GENOA CHARTER TOWNSHIP BOARD
Regular Meeting
Tuesday, September 2, 2025
6:30 p.m.

BOARD PACKET

TO: Honorable Board of Trustees
FROM: Amy Ruthig, Planning Director
DATE: August 26, 2025
RE: 6025 Brighton Road, vacant parcel #4711-27-400-012 Private Road Special Land Use, Site Plan and Environmental Impact Assessment

Attention:	Amy Ruthig, Planning Director
Subject:	Olde Barn Court – Private Road and Special Land Use Review #2
Location:	6025 Brighton Road – north side of Brighton Road, east of Clifford Road
Zoning:	LDR Low Density Residential

TITLE
SITE PLAN

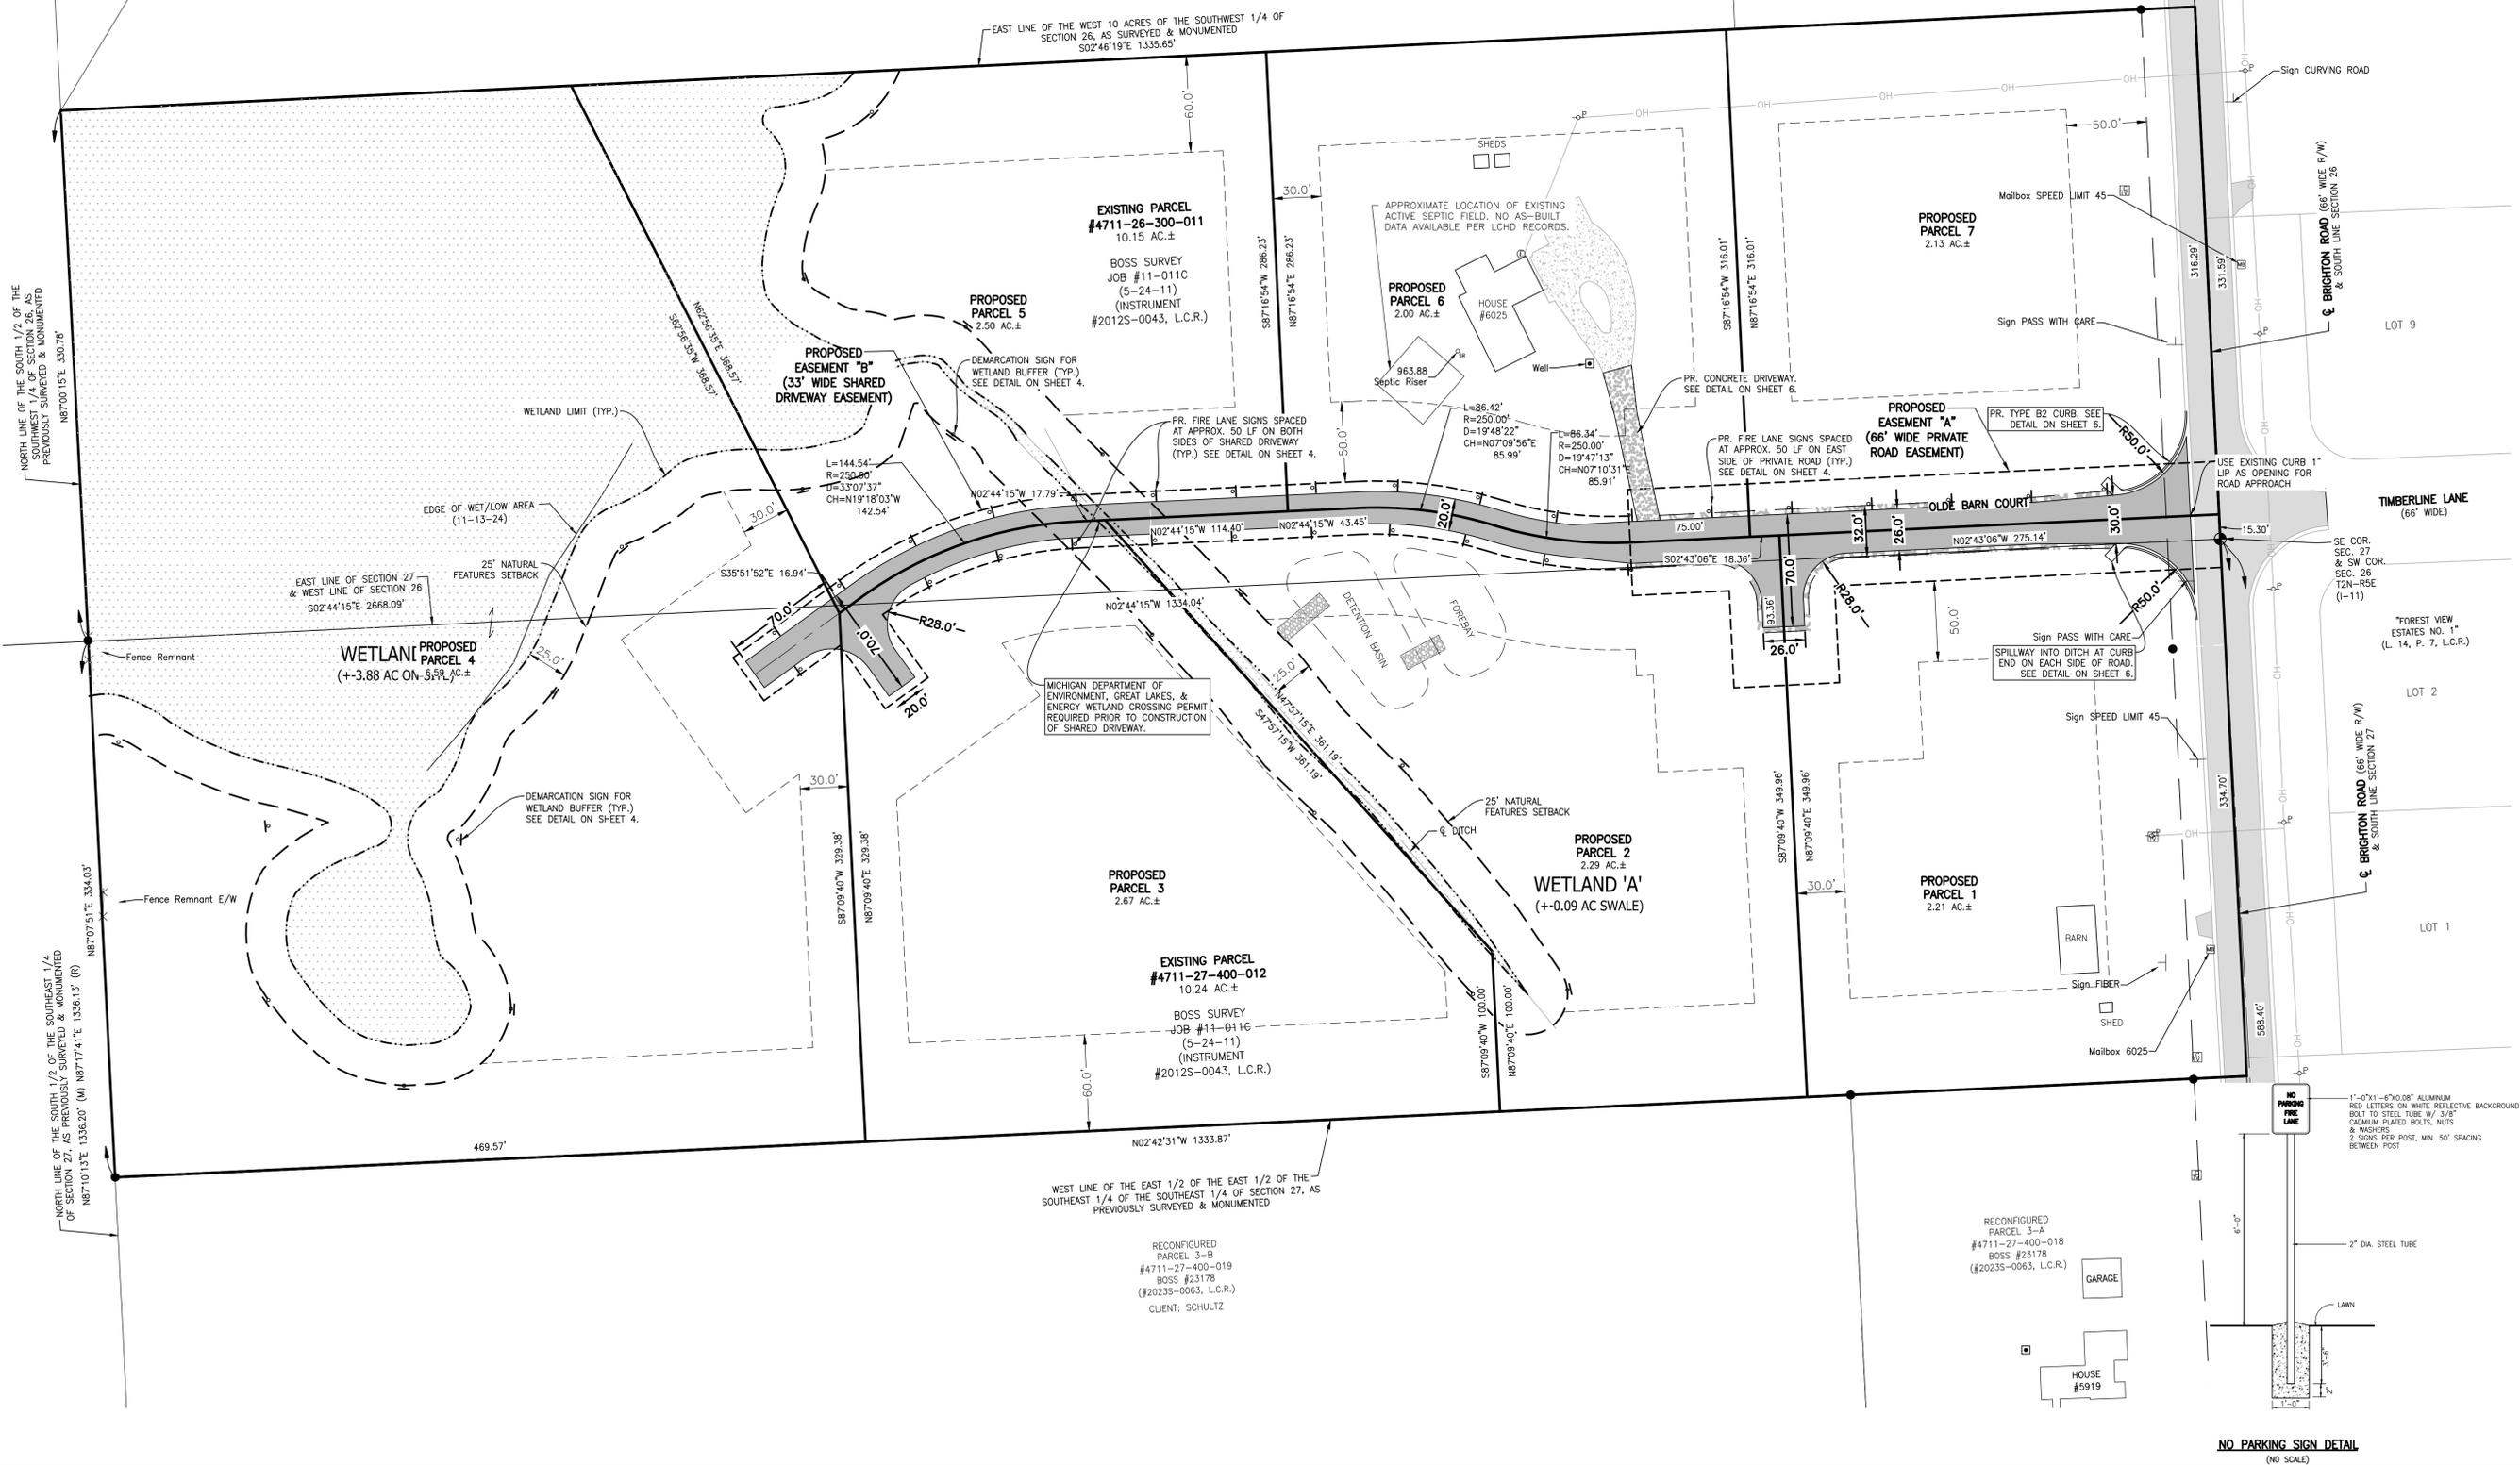
- 2. AASHTO Standards.** The applicant must address any comments provided by the Township Engineer with respect to this standard.
- 3. Easement Width.** The typical private road cross-section on Sheet 6 depicts a 66-foot wide easement. This standard is met.
- 4. Road Design.** The proposed roadway width is 26 feet, which complies with the Ordinance requirement for residential lots of 2 acres or more.
- 5. Maximum Length/Turnarounds.** In total, the proposed private road and shared residential driveway are approximately 900 feet in length. Two tee turnarounds are provided, as required.

- 10. Boulevard Medians.** The proposal does not include a boulevard median.
- 11. Vertical Clearance.** A note on Sheet 4 states that “a minimum vertical clearance of 15 feet shall be maintained along the length of all apparatus access roads.” This standard is met.
- 12. Street Names.** Street names are subject to County approval following review and comment by the Township.

13. **Signs.** A note on Sheet 4 states that street signs will comply with the Michigan Manual of Uniform Traffic Control Devices and Road Commission standards, as required.
14. **Yard Setback.** The proposed private road easement does not abut an exterior property line.
15. **Impact Assessment.** The submittal includes an Environmental Impact Assessment, as required.
16. **Project Phasing.** A note on Sheet 4 states that “the private road, shared driveway, and infrastructure are proposed to be built in a single phase.”

1. Section 15.05.03.d of Genoa Township's Ordinance states that for any single means of access serving more than five lots, it shall include a turn-around with a center landscaped island or continuous loop. A hammerhead turnaround is provided in the plan set. This ordinance requirement may be adjusted by the planning commission in particular cases. This layout should be approved by the fire department prior to site plan approval.
2. Brighton Area Fire Authority has required that the width of the private road be increased to 26-foot wide from the 22-foot road width required in the Genoa Township Zoning Ordinance. Due to this, the gravel shoulder has been reduced from 5 feet to 3 feet wide and we have no engineering related concern to this reduced shoulder width.

- All conditions stated in the township engineer and township planner's review letters shall be met.
- The petitioner shall have receipt of a permit from EGLE for the wetland crossing prior to the issuance of Land Use Permit.
- The hammerheads for Parcels 3 and 4 shall be identified as being utilized for the driveways for their concurrent parcel.
- Delineation signs for the wetlands shall be added to the site plan prior to presentation to the Township Board.
